Bulletin #: TB970703 62mm Crossbar Ball and Socket Fittings Date: 7/3/97 Page 1 of 1

First set:

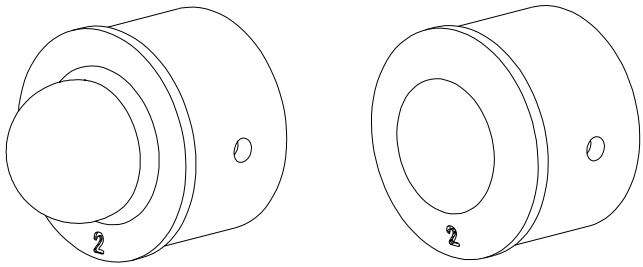
15J-2110	SOCKET	XBAR CENTER BALL JOINT 62	FITS 60/62 MM
15J-2120	BALL	XBAR CENTER BALL JOINT 62	FITS 60/62 MM

This set is used on the Falcon 195 and Falcon 225.

These two types of ball socket joints cannot be interchanged.
